Access Compliance Report

Public Rights-of-Way

(Curb Ramps)

Intersection ID: 45068	Main Street: DARBYWINE_DR	Cross Street: PAULINE_LN	Location: NW
ADA ID: 96F25C31062B	Ramp Type: PerpDiag	Initial Pass/Fail: Pass	Overall Compliance: No
Codes/Mitigation Info/Possible Solution		Field Measurements/Component Compliance	
		Severity Score: 5

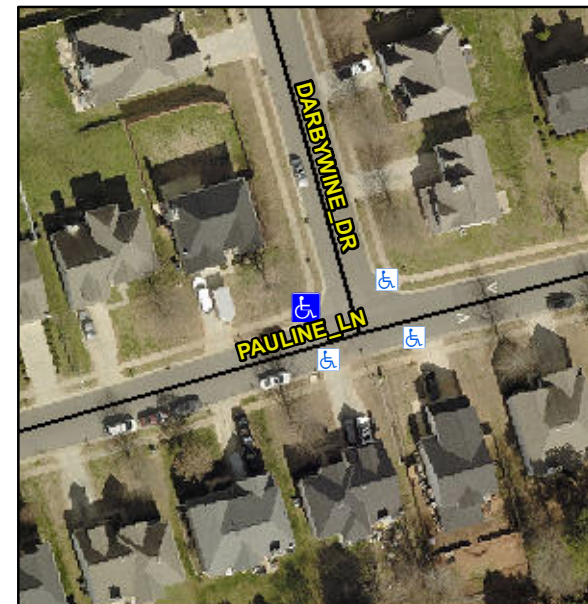
Not Found, R305.2, R304.5.4

Remove & Replace Curb Ramp With Two New Directional Ramps or Equivalent. Remove & Replace Gutter.
